UNITED STATES PATENT AND TRADEMARK OFFICE

APPLICATION NO.	FILING DATE	FIRST NAMED INVENTOR	ATTORNEY DOCKET NO.	CONFIRMATION NO.
09/975,163	10/11/2001	Daniel Xu	INTO-0008-US(P12501)	9107
7590	02/12/2004		EXAMINER	
Timothy N. Trop TROP, PRUNER, HU, P.C. 8554 KATY FWY, STE 100 HOUSTON, TX 77024-1805			KEBEDE, BROOK	
			ART UNIT	PAPER NUMBER
			2823

Office Action Summary

DETAILED ACTION

FIG. 1

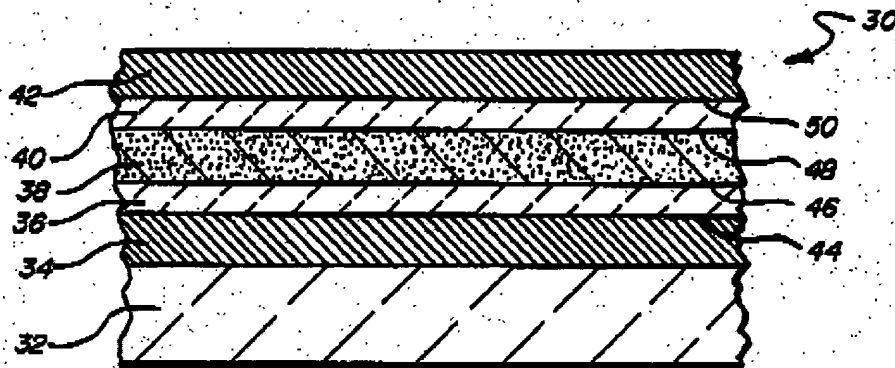
In response to the applicant's argument, the Examiner respectfully submits that such an argument is not commensurate with the scope of the claims, in particularly, as stated above. The Examiner respectfully submits that, in contrary Applicant's argument, Pryor et al. '533 teach forming trench using the tapered electrode as mask. The Examiner respectfully submits Figs. 1-3 of Pryor et al. '533 herein below:

As shown above, layers **38**, **40** and **42** are etched the form the tapered electrode as depicted in Fig. 2 as follows:

FIG. 2

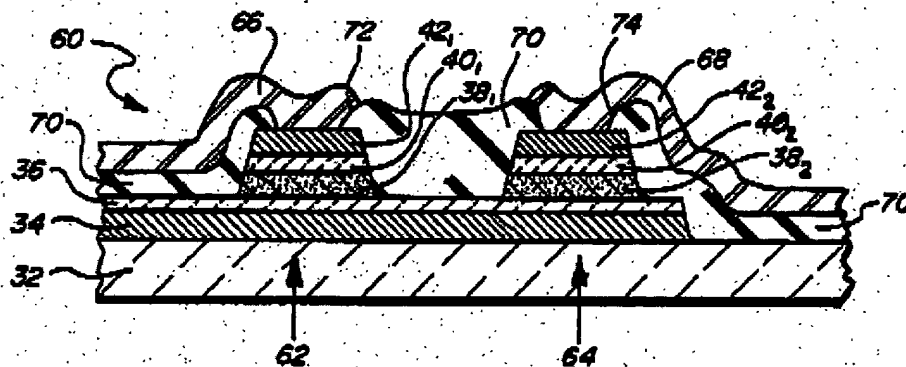
Note that in Fig. 2, layers **34** and **36** are not etched. However, in Fig. 3 layers **34** and **36** are etched using the tapered electrode (**38 40 42**) as a mask as shown below in Fig. 3 to form a trench (cut in).
